ADDENDUM NO. - 04

Date: 05/08/2026

Hamilton County – Paycor Stadium
1 Paycor Stadium Cincinnati, OH 45202
Paycor Southeast/Southwest Escalators - Demolition

ITB 033-26

DRAWING NUMBER ISSUE
A-213.9 2.4

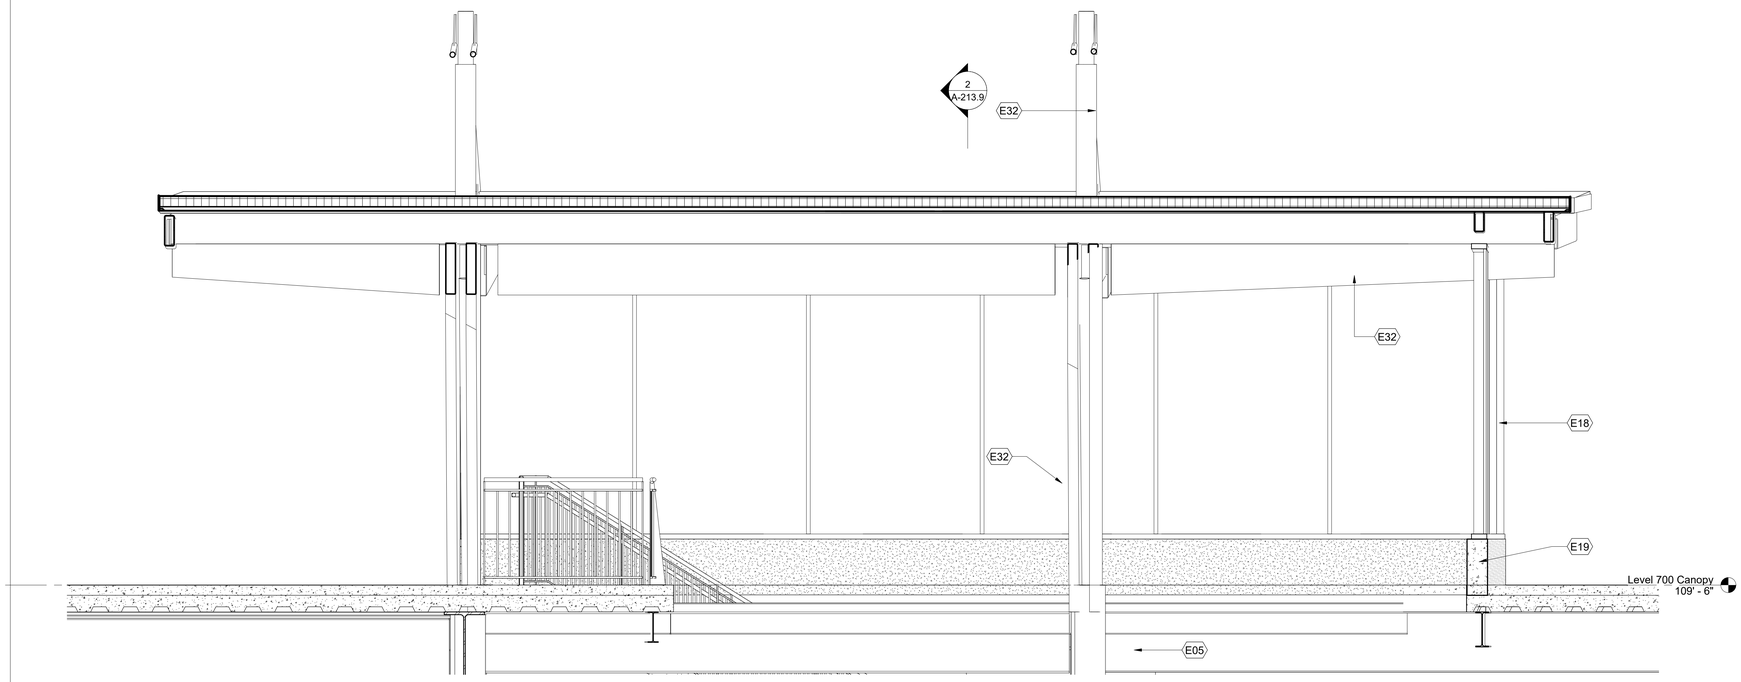
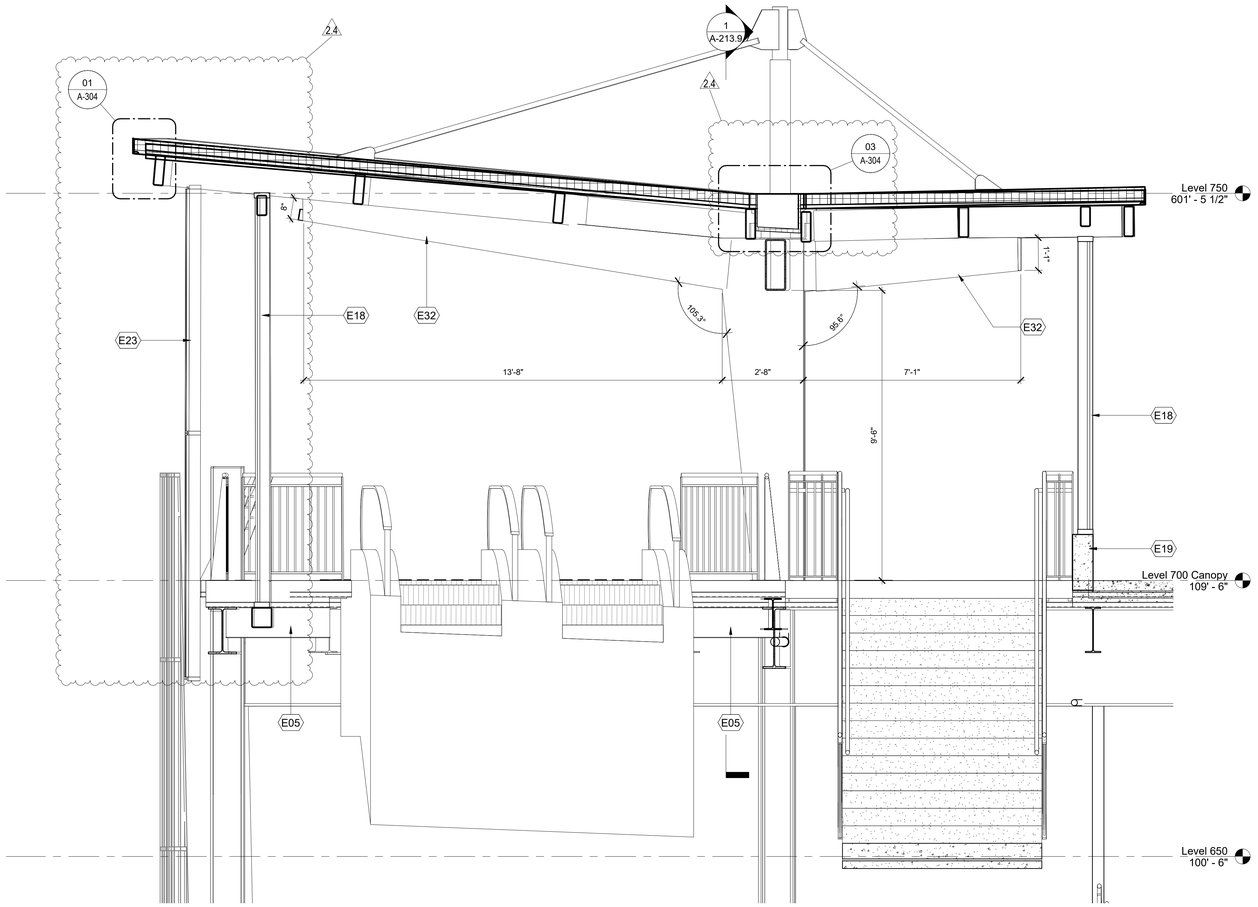
2.8.A-213.4, A- 213.9
2.8.1. Revision to center gutter.
2.8.2. Detail Markers added.

DRAWING NUMBER	ISSUE
A-301	2.4

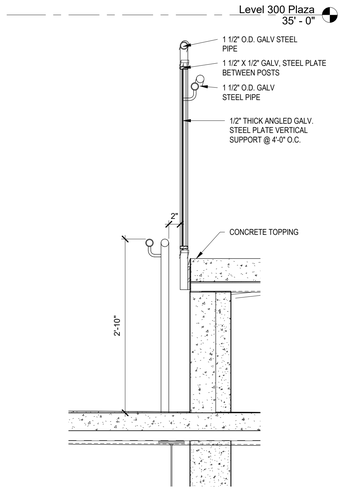
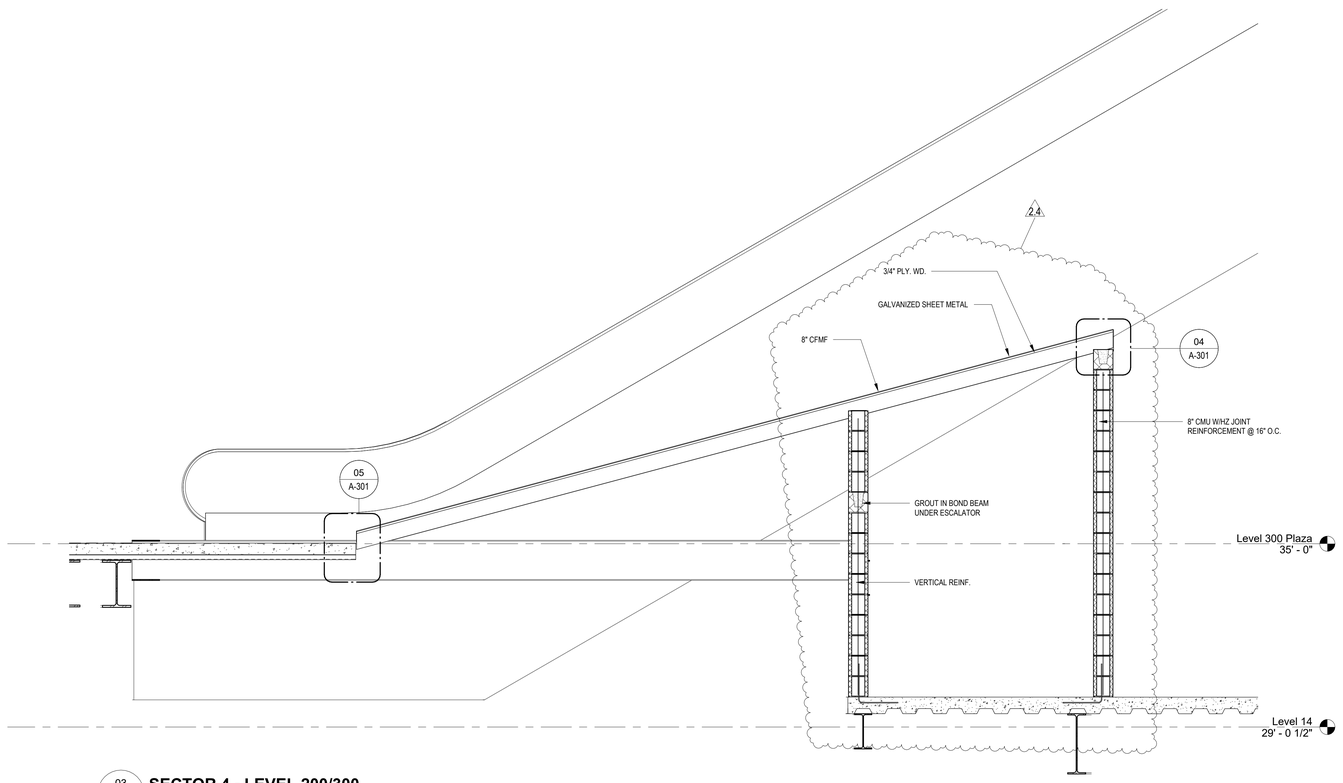
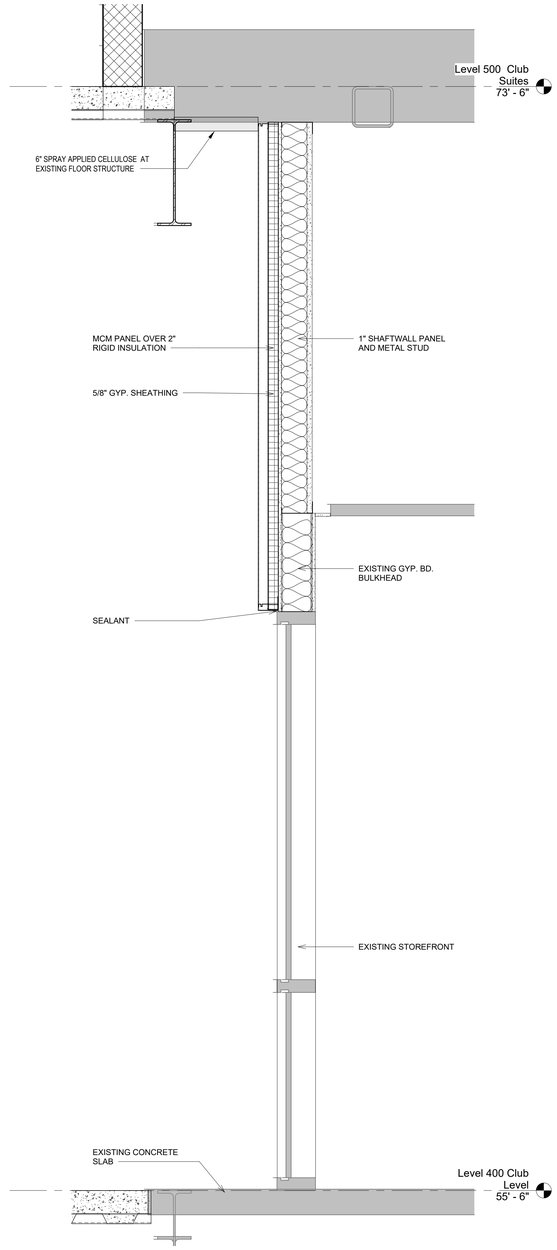
2.9.A-301
2.9.1. Revision to CMU Wall.

DRAWING NUMBER	ISSUE
A-302	2.4

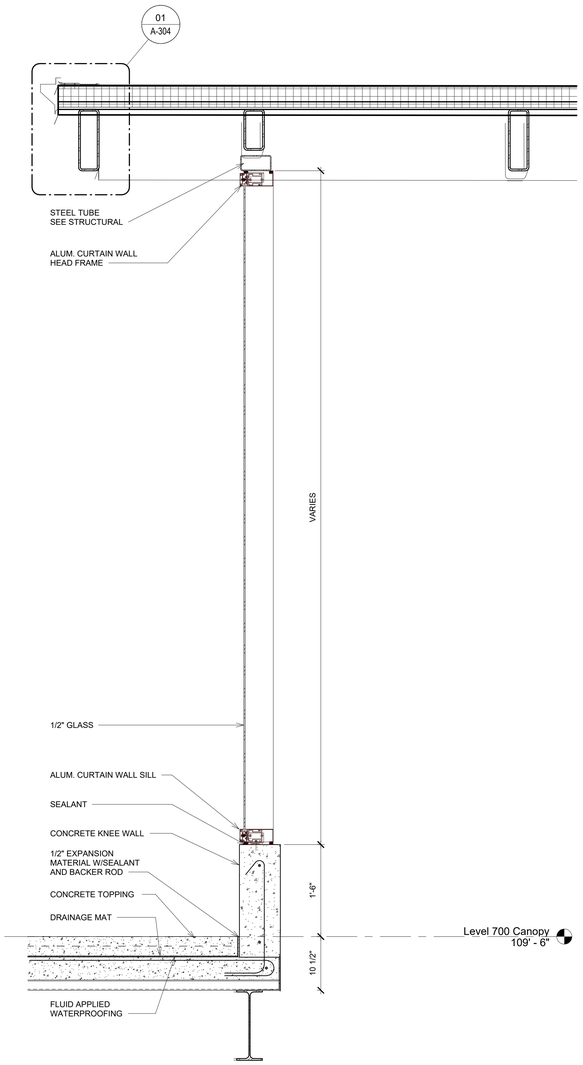
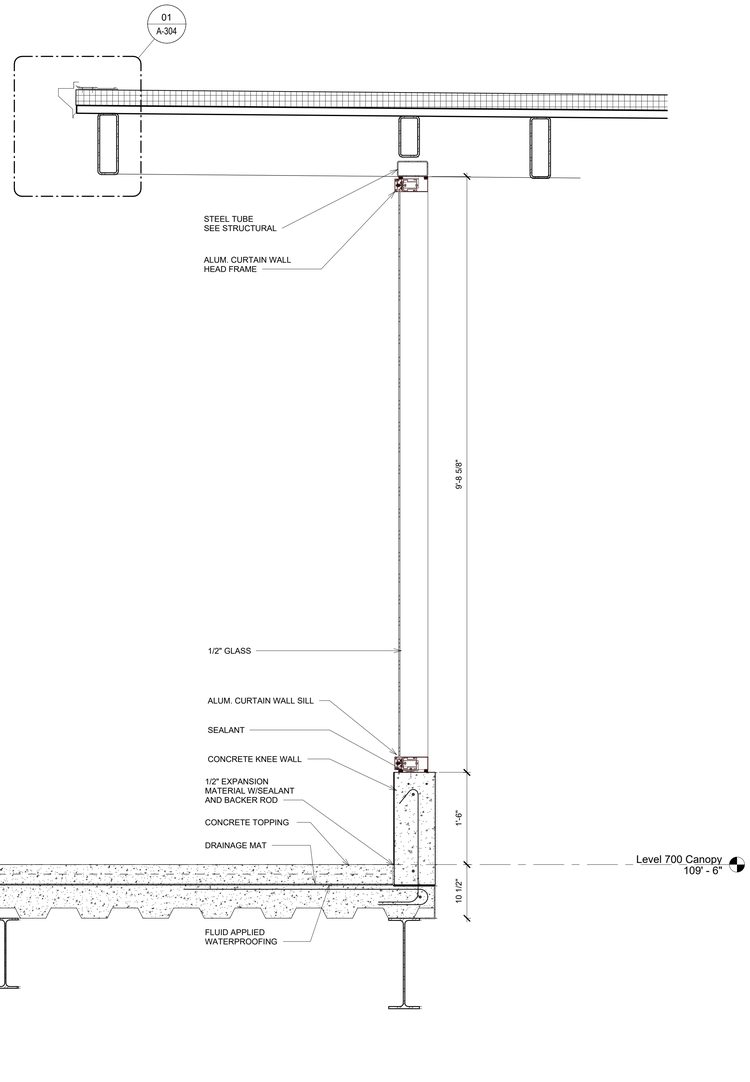
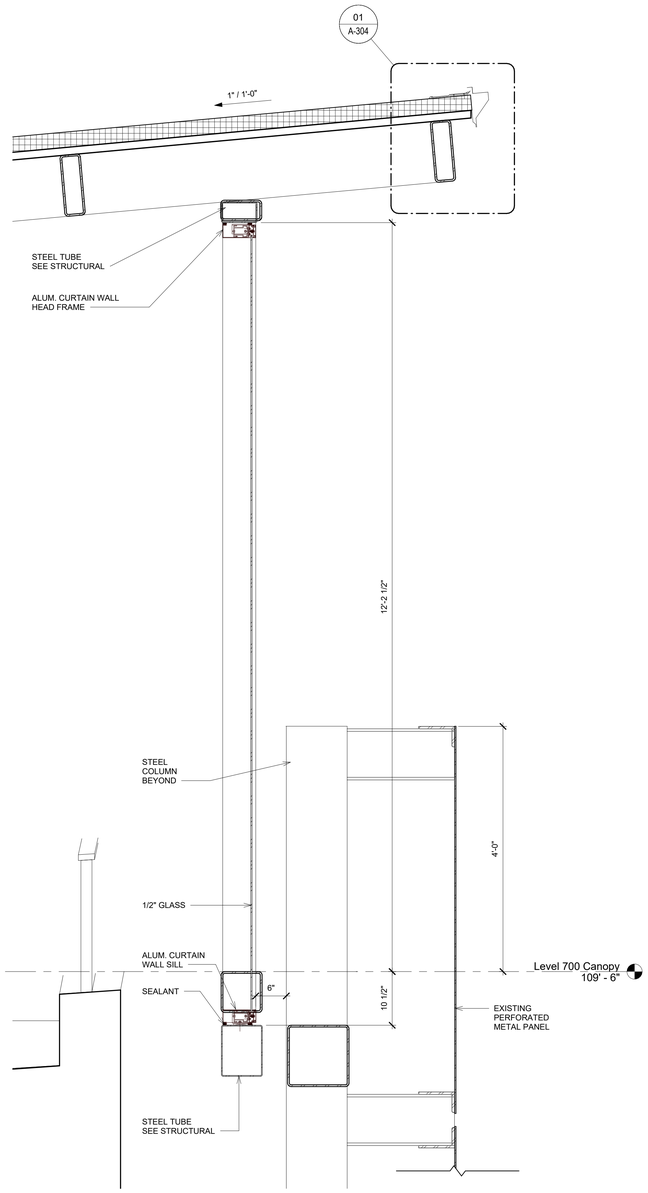
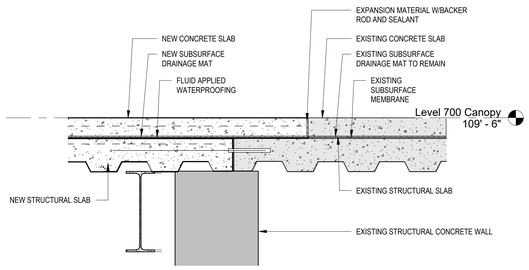
2.10.A-302, A303
2.10.1. New Wall Section Sheet.

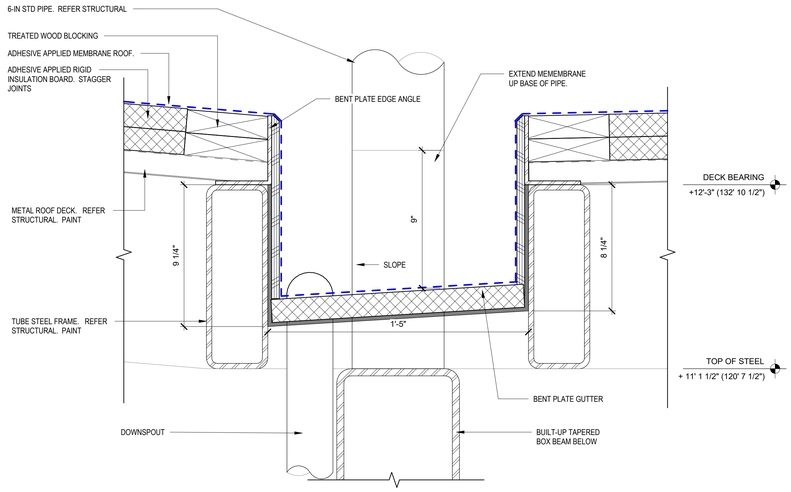
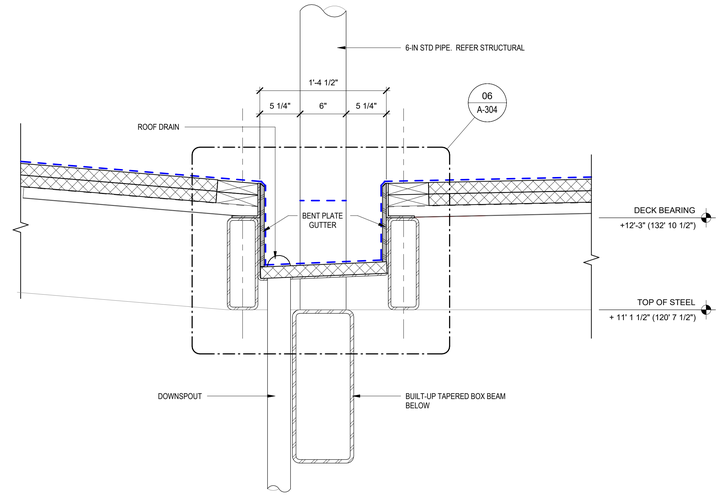
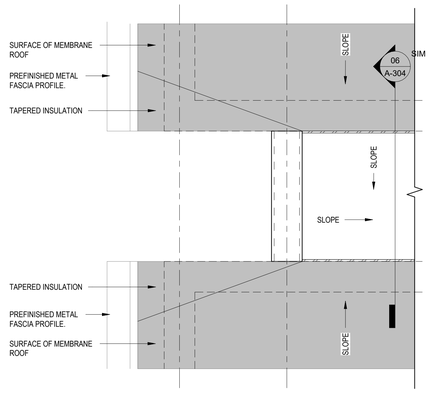
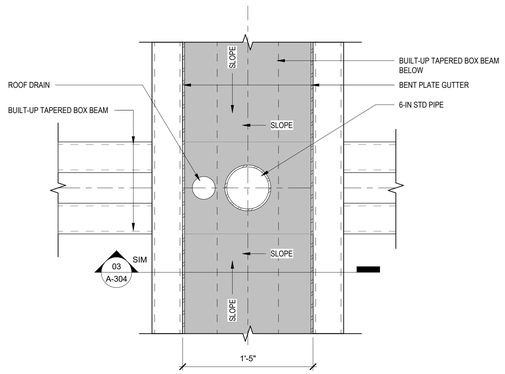
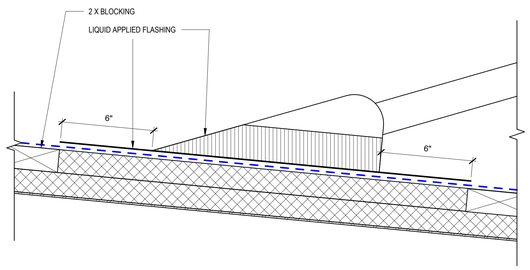
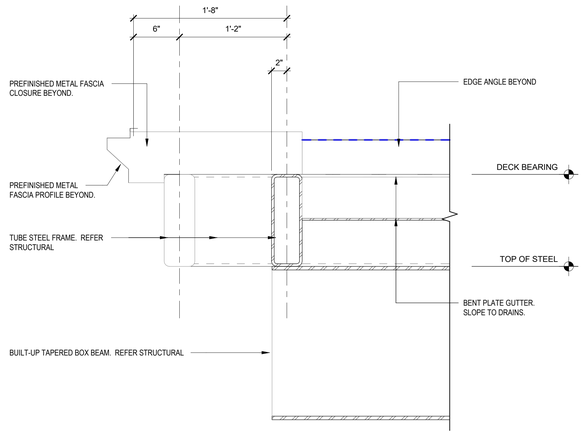
2.11.A-304
2.11.1. New Sheet with roof details.

DRAWING NUMBER	ISSUE
S-106	2.4

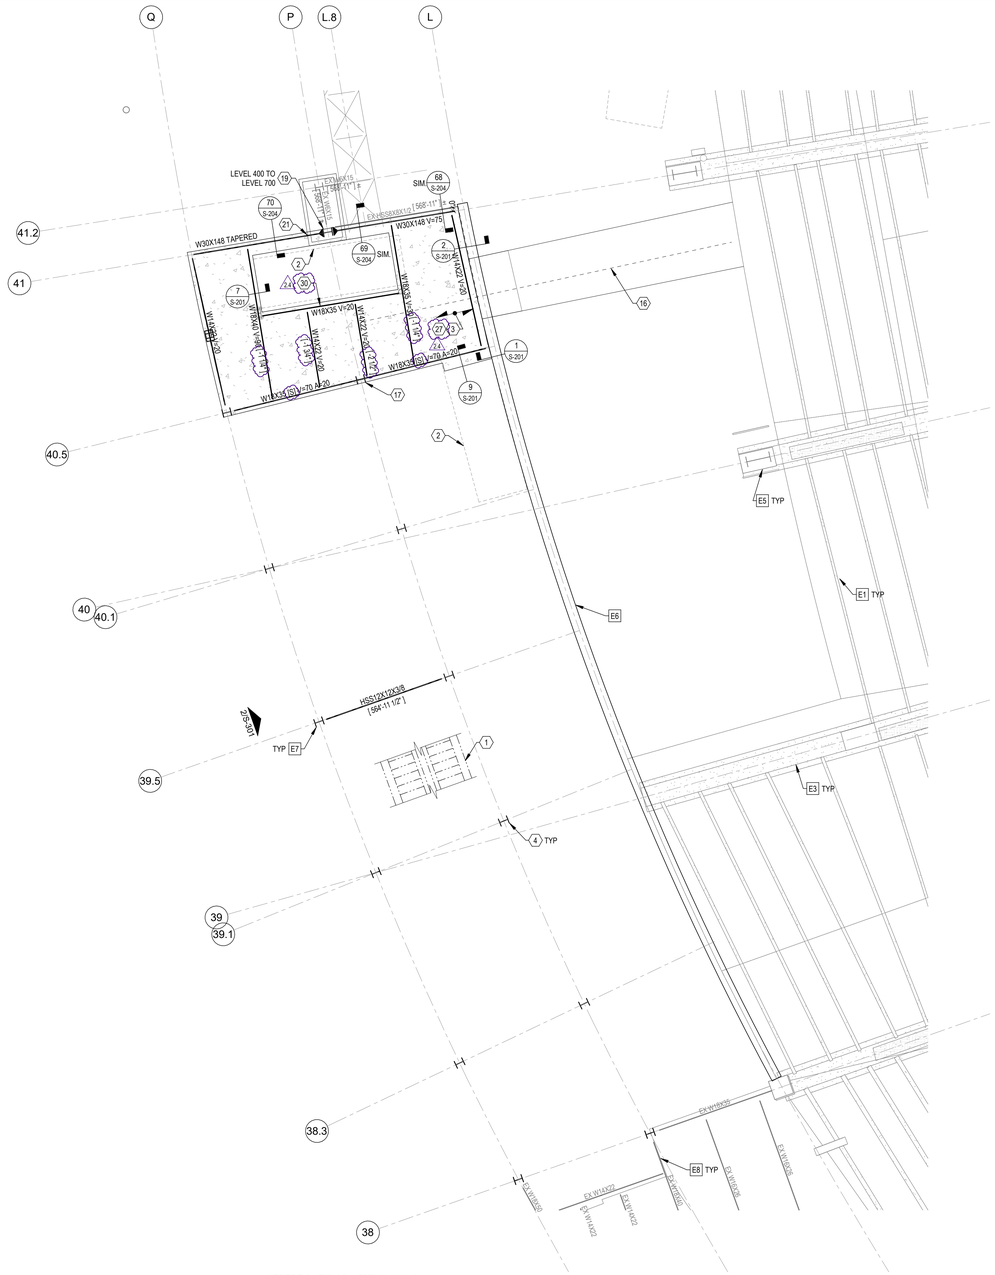
2.17.S-106
2.17.1. Refer to sheet for clouded revisions
2.17.2. Framing revisions

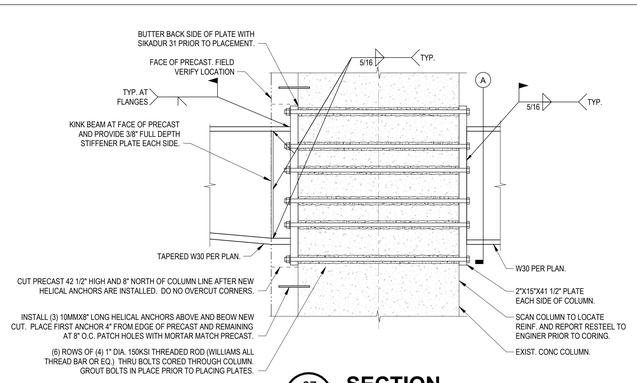
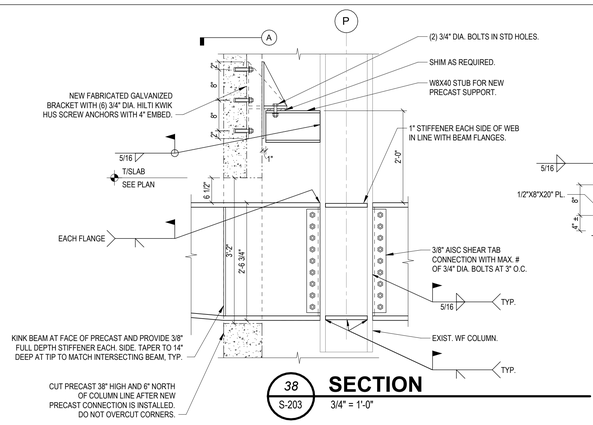
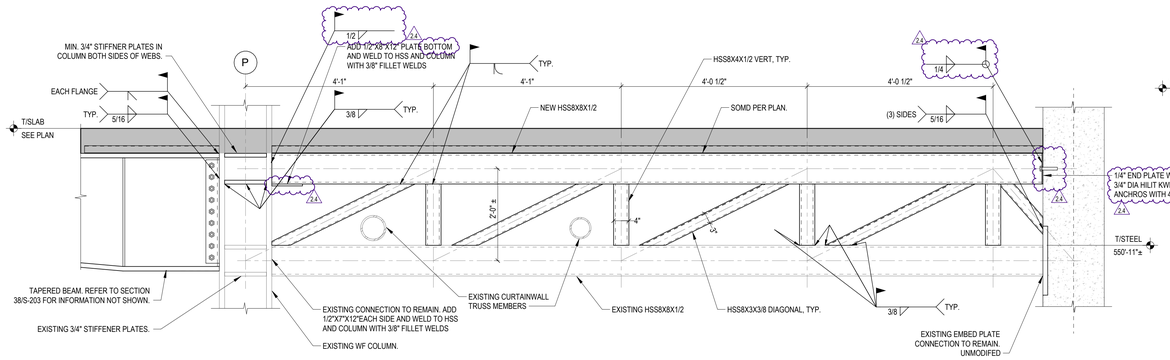
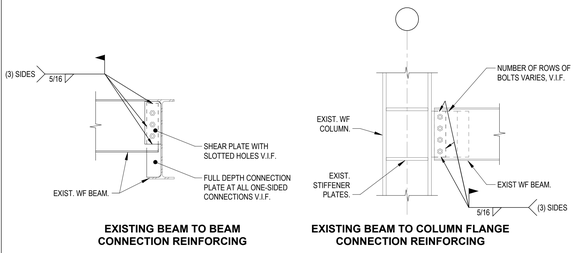
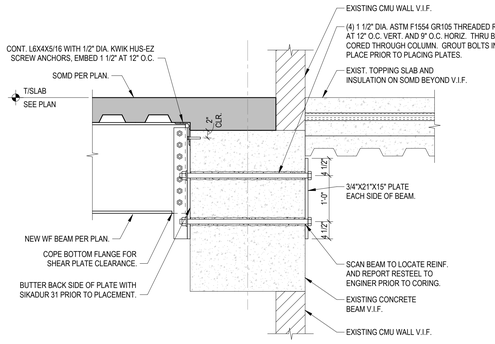
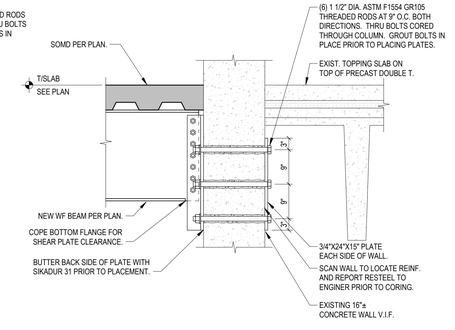
2.21.S-203
2.21.1. Refer to sheet for clouded revisions
2.21.2. Updated details for clarification
